CITY OF PORTLAND, MAINE DEVELOPMENT REVIEW APPLICATION 2004-0217 PLANNING DEPARTMENT PROCESSING FORM Application I. D Number **DRC Copy** 17ACENTE 10/19/2004 Selberg Carl E Application Date Applicant 121 Carlyle Rd, Portland, ME 04103 Joseph Ave Applicant's Mailing Address Project Name/Description Joseph Ave, Portland, Maine Consultant/Agent Address of Proposed Site Agent Ph: Agent Fax: 172 F001001 Applicant or Agent Daytime Telephone, Fax Assessor's Reference: Chart-Block-Lot Proposed Development (check all that apply): New Building **Building Addition** Change Of Use Residential Office □ Retail Manufacturing Warehouse/Distribution Parking Lot Other (specify) 32' x 49' Proposed Building square Feet or # of Units Zoning Acreage of Site Check Review Required: Site Plan Subdivision **PAD Review** 14-403 Streets Review (major/minor) # of lots Flood Hazard | HistoricPreser/ation DEP Local Certification Shoreland Zoning Conditional Zoning Variance Other Use (ZBA/PB) Fees Paid: Site Pla \$250.00 Subdivision Engineer Review Date 10/19/2004 Reviewer **DRC Approval Status:** Approved w/Conditions □ Approved Denied See Attached Approval Date (2-30 Approval Expiration Additional Sheets Attach

SELBERG RESIDENCE		SIRUCTURALS
HOUSE CALLS INC.	HOME PLANNING & DESIGN PRIMING	151 ROOSEVELT TRAIL, WINDHAM, ME

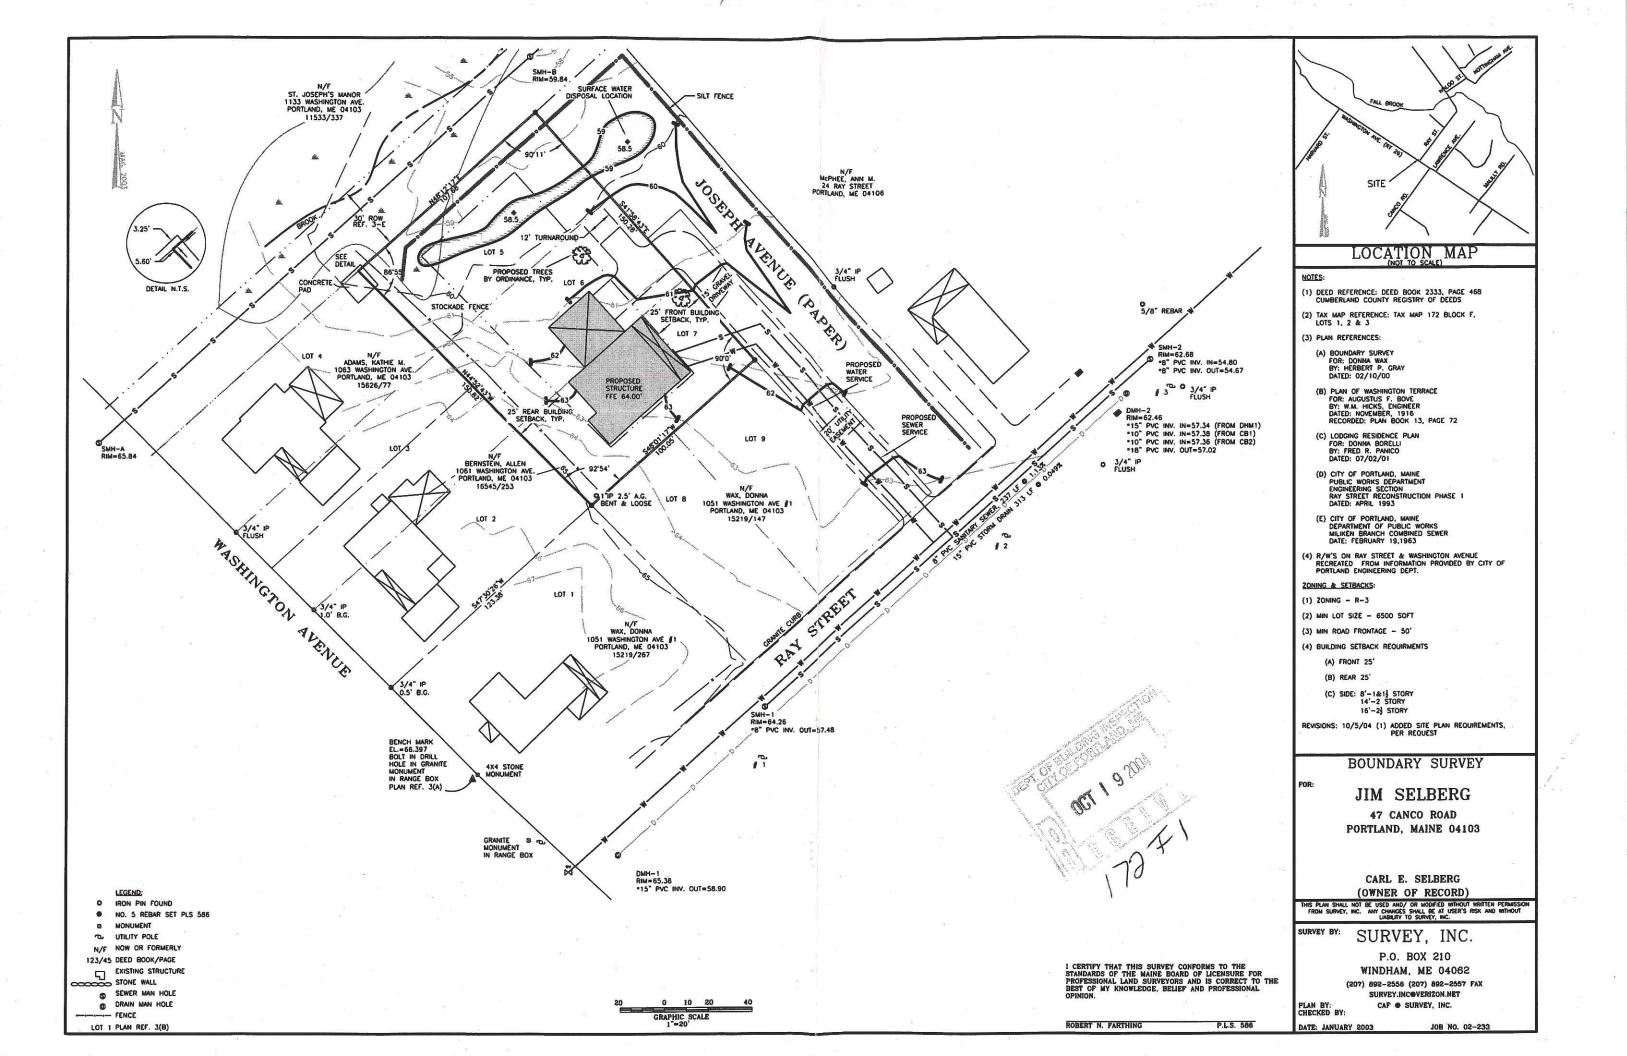
First, your site plan does not match your building plans. All dimensions shall match before a permit application can be adequately reviewed. It is also noted that there is a rear sliding door with no rear deck or stairs being provided. ALL structures that are to be approved as part of this permit application SHALL be shown on both the site plan and the structural plans.
